Access Compliance Report

Public Rights-of-Way

Intersection ID: 19118	Main Street: BEVERWYCK_RD	Cross Street: COLONY_RD	Location: SE
ADA ID: 896CD86FF987	Ramp Type: PerpDiag	Initial Pass/Fail: Fail	Overall Compliance: No
		Severity Score: 12.5

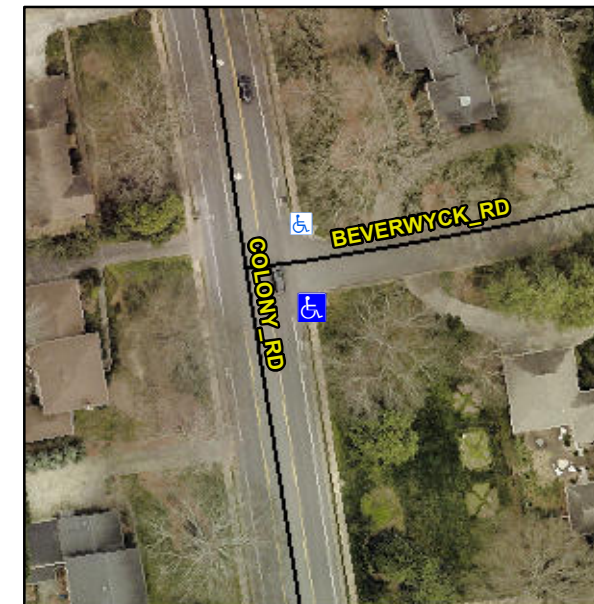
Compliance	Description	Data	Compliance	Description	Data
N/A	Ramp Length (in)	55.0	Yes	Ramp Slope (%)	5.2
Yes	Ramp Width (in)	48.0	No	Ramp XSlope (%)	5.4
N/A	Flare Type LT	N/A	N/A	Flare Type RT	N/A
N/A	Flare Slope LT (%)	N/A	N/A	Flare Slope RT (%)	N/A
N/A	Flare Traversable LT?	N/A	N/A	Flare Traversable RT?	N/A
N/A	Landing Length (in)	N/A	N/A	DWS Provided?	N/A
N/A	Landing Width (in)	N/A	N/A	DWS Contrast?	N/A
N/A	Landing Slope (%)	N/A	N/A	DWS Length (in)	N/A
N/A	Landing X Slope (%)	N/A	N/A	DWS Full Width?	N/A
N/A	Landing Curb? (Y/N)	N/A	N/A	DWS Offset (in)	N/A
N/A	Shared Landing?	N/A			
N/A	Gutter Ponding?	N/A	N/A	Gutter Slope (%)	N/A
N/A	Gutter Lip Ht (in)	N/A	N/A	Gutter X Slope (%)	N/A
N/A	Painted X Walk1?	No	N/A	Painted X Walk2?	No
	X Walk 1 Direction	To N		X Walk 2 Direction	To W
N/A	X Walk 1 Width (in)	N/A	N/A	X Walk 2 Width (in)	N/A
	X Walk 1 Slope (%)	3.1		X Walk 2 Slope (%)	6.5
	X Walk 1 X Slope (%)	0.1		X Walk 2 X Slope (%)	0.7

Remove & Replace Curb Ramp With Two New Directional Ramps or Equivalent.
